ENGINEERING TECHNICAL BULLETIN No. 107

**Improving the Noise Level
of the
SP-600 Receiver
using a
Nuvistaplug**

March 1965

FIGURE 1- NUVISTA PLUG SCHEMATIC

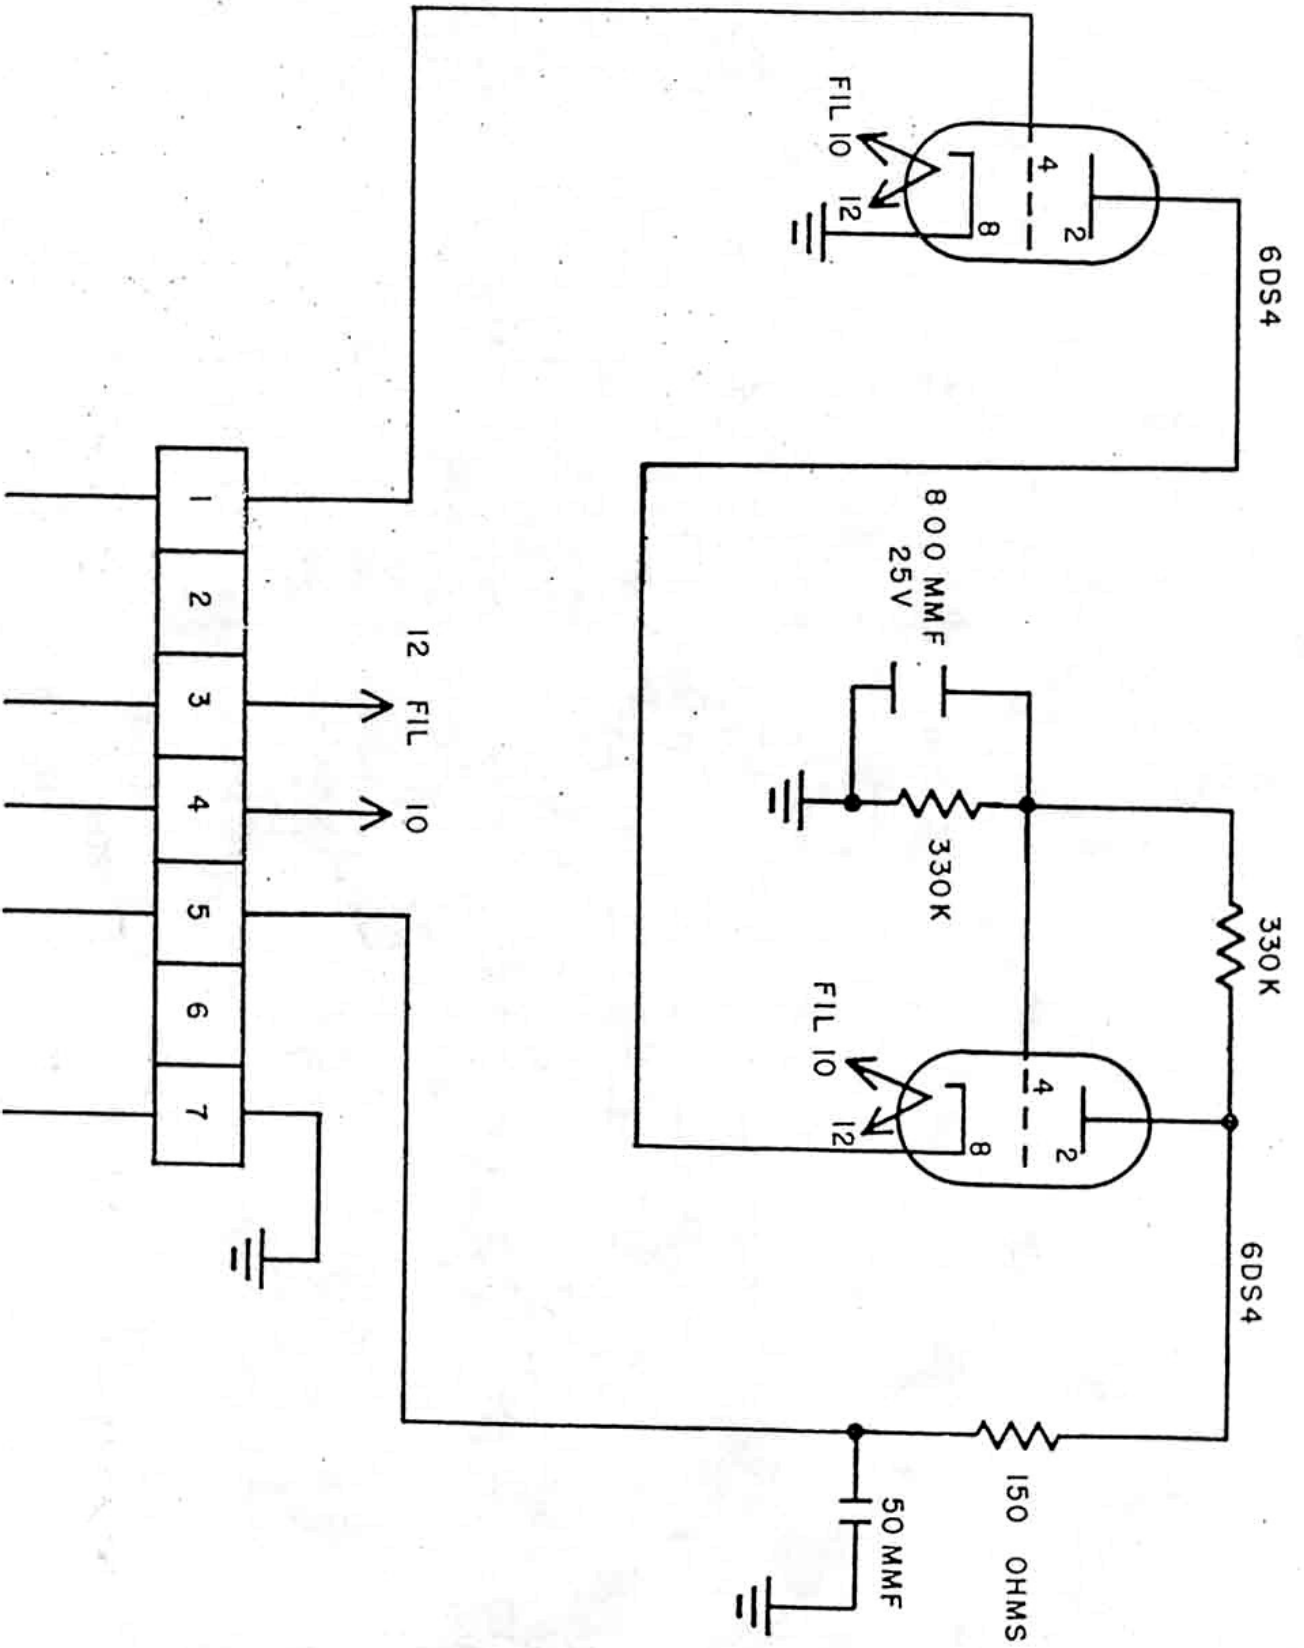
By combining the miniature, low noise, high amplification triodes (RCA Nuvisitor Type 6DS4) in a cascade arrangement, the Nuvistaplug is able to take advantage of the triode's low noise while retaining, essentially, the desirable amplification characteristics of the pentode it replaces (See Schematic, Figure 1). No circuit changes are necessary when the Nuvistaplug is used, and only slight compensating adjustments are needed in most cases.

FIGURE:2 NUVISTA PLUG IN SP-600

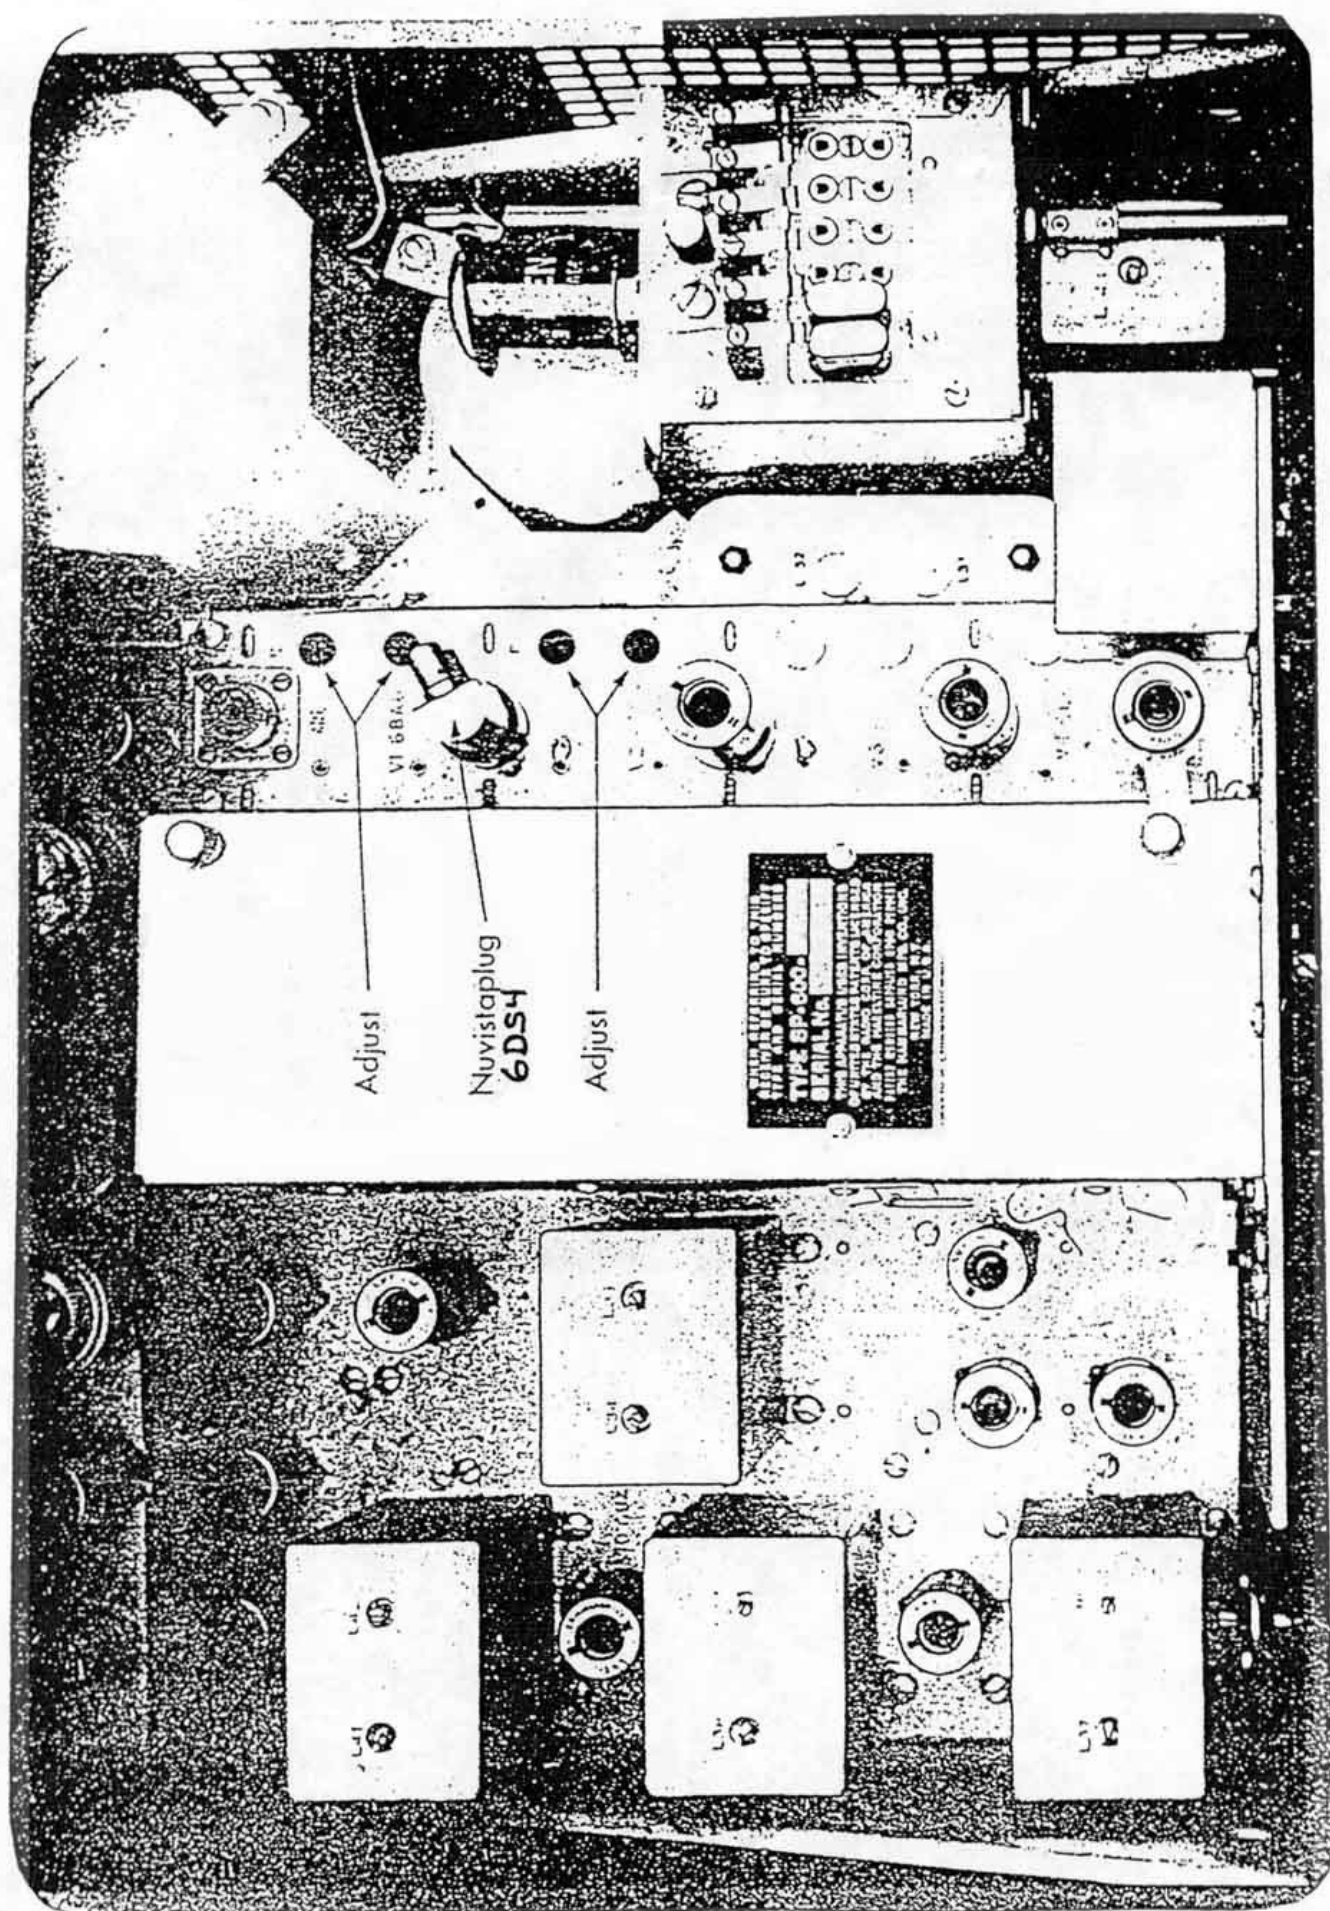
6. Adjust the trimmers for the antenna and the first RF stage while listening to the tone output (See Figure 2). Each time an improvement is made, decrease the amplitude of the CW generator output so that the audio tone is barely heard under the internally generated white noise of the receiver. In most cases the two trimmer capacitors marked "C" need to be readjusted, but the two trimmer inductors marked "L" do not need readjustment.
